RE: **Lot 12, Blk 1 Cliffs Unit 22 SAD 228**
8000 Alto Rey Ct. NW
Grading and Drainage Plan
Engineers Stamp Date 10/29/2020 (D10D003N12)
Pad Certification Date: 3/11/2021

Based upon the information provided in your submittal received 4/19/2021, this plan is approved for Building Permit.

SHEET TITLE: GRADING AND DRAINAGE PLAN

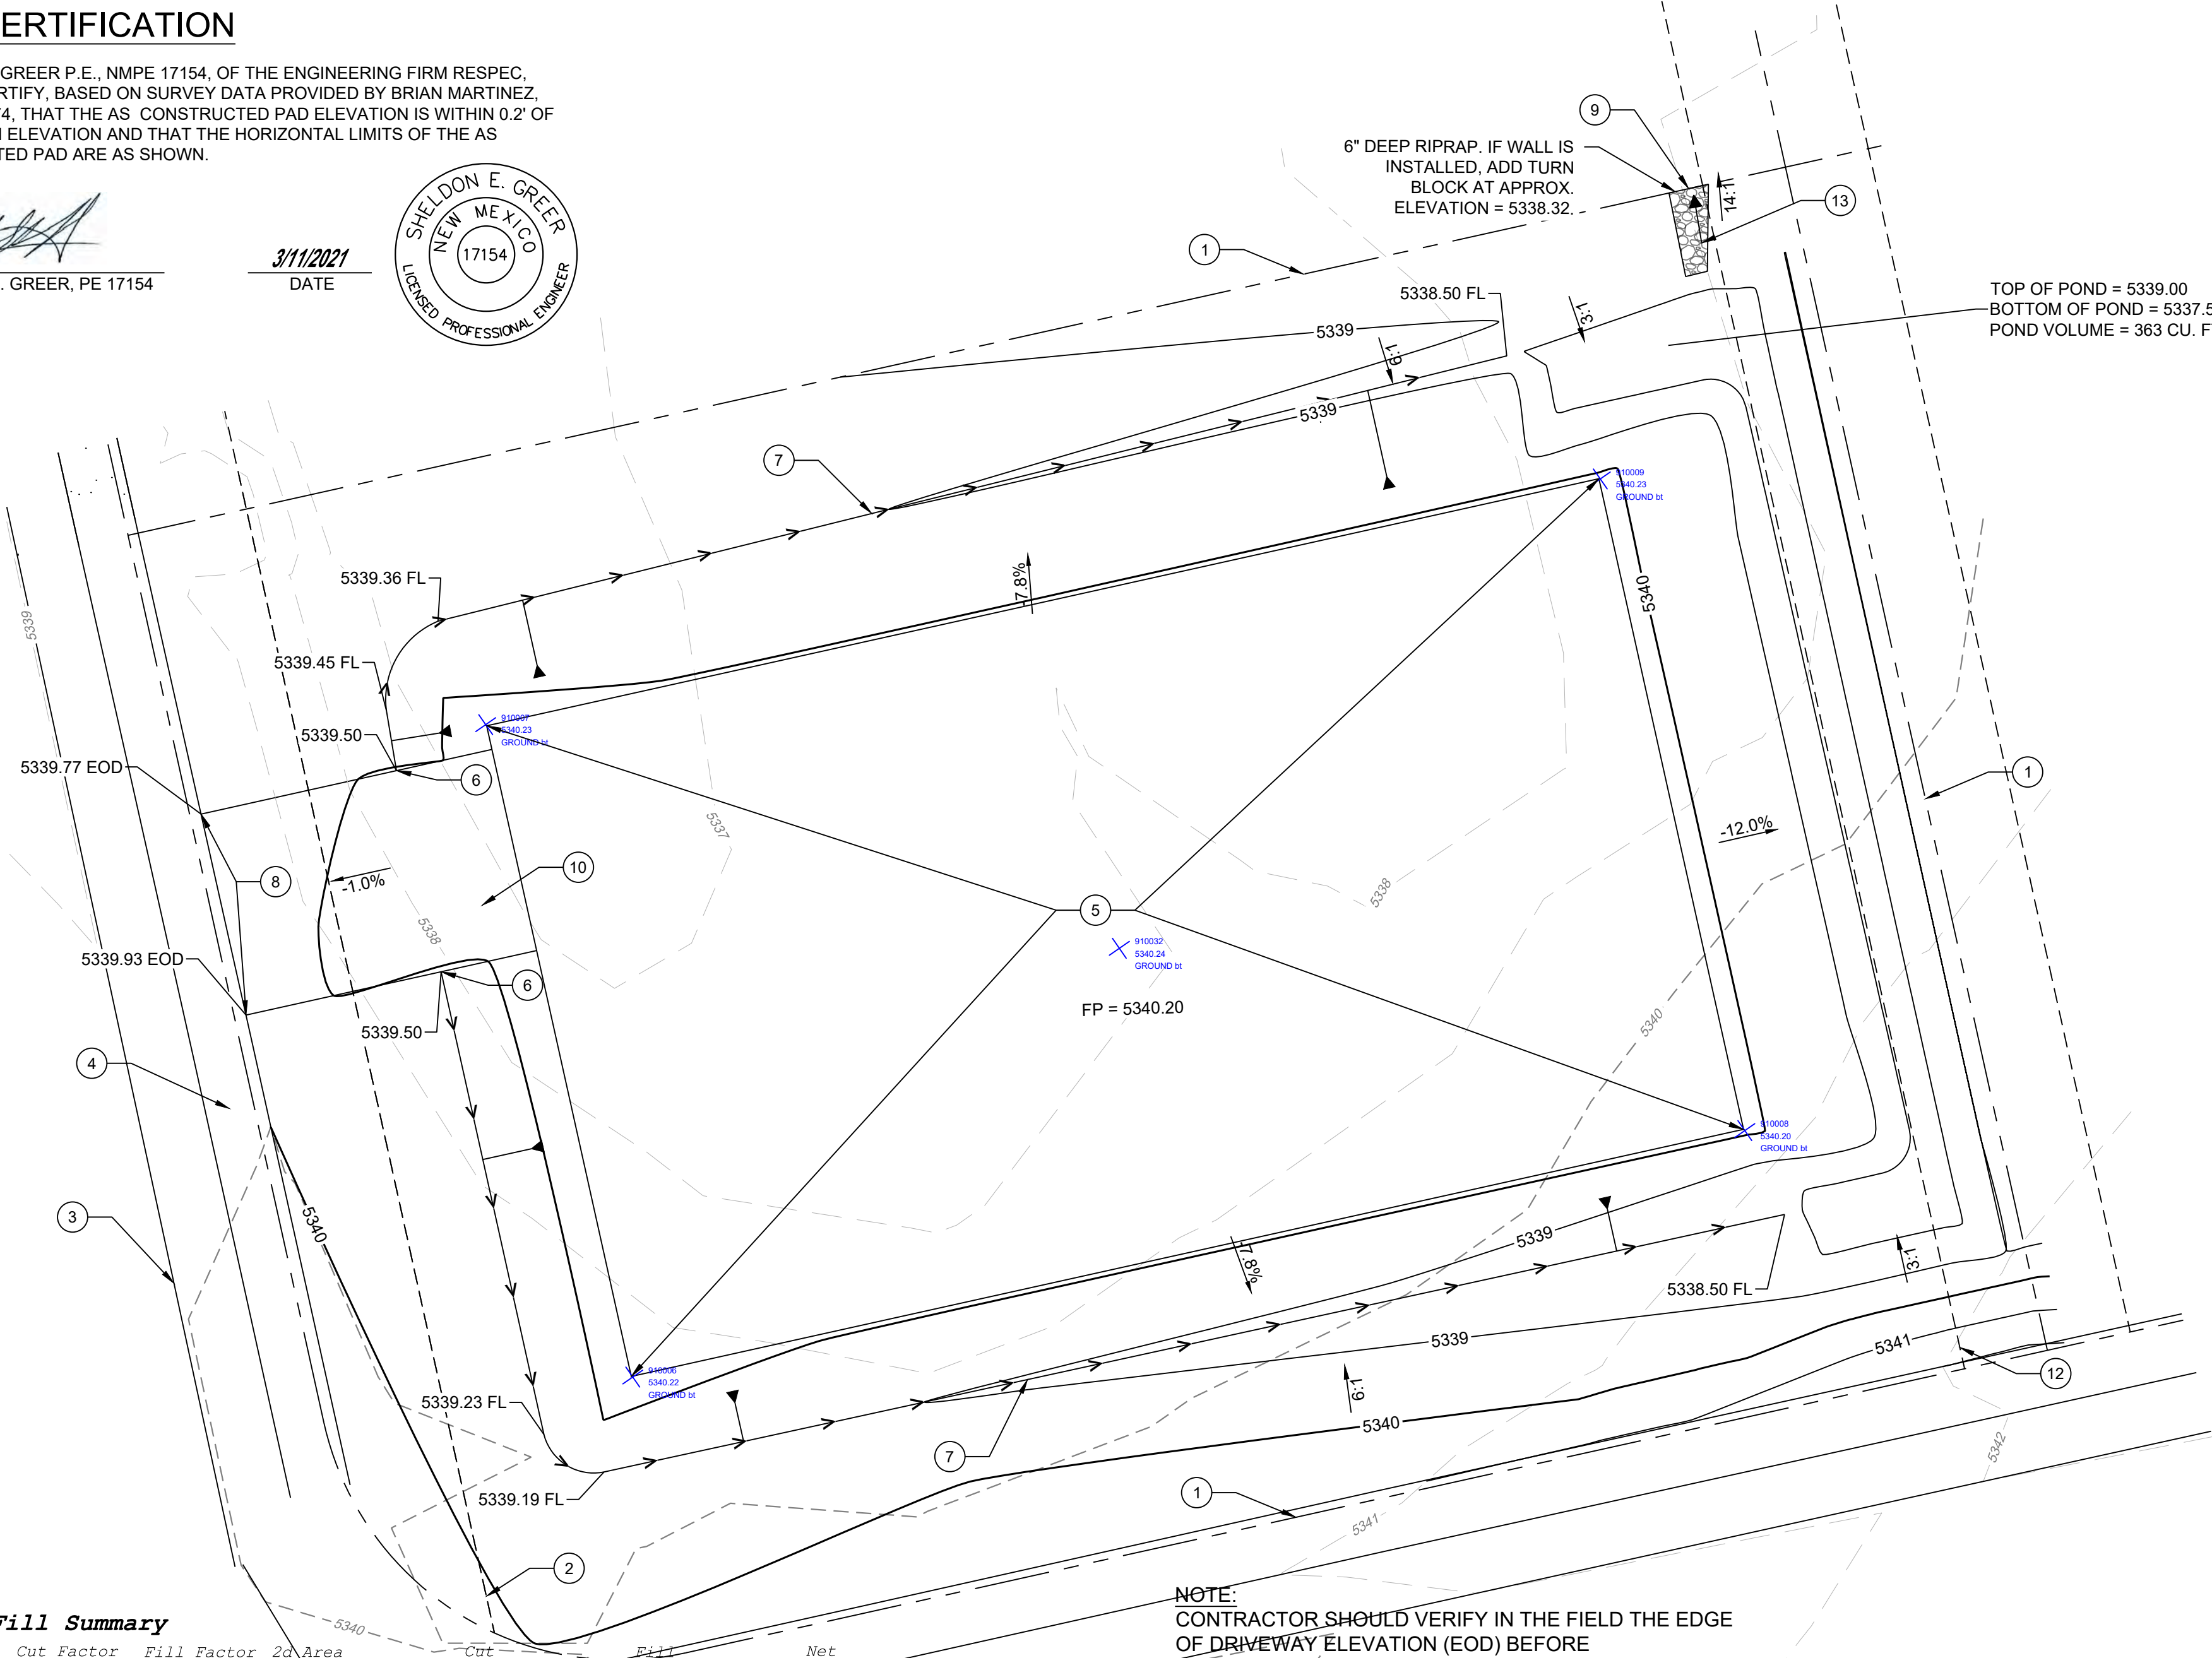
Please attach a copy of this approved plan to the construction sets in the permitting process prior to sign-off by Hydrology.

Prior to Building permit approval a Pad Certification will be required, provided by the Engineer or a registered Land Surveyor.

Reiterate to the Owner/Contractor that a separate permit for a garden/retaining wall must be obtained with the approved G&D plan and Pad Certification. **Also, if a swimming pool is to be placed the grading and drainage plan will change and will need to be resubmitted.**

Prior to Certificate of Occupancy release, Engineer Certification per the DPM checklist will be required.
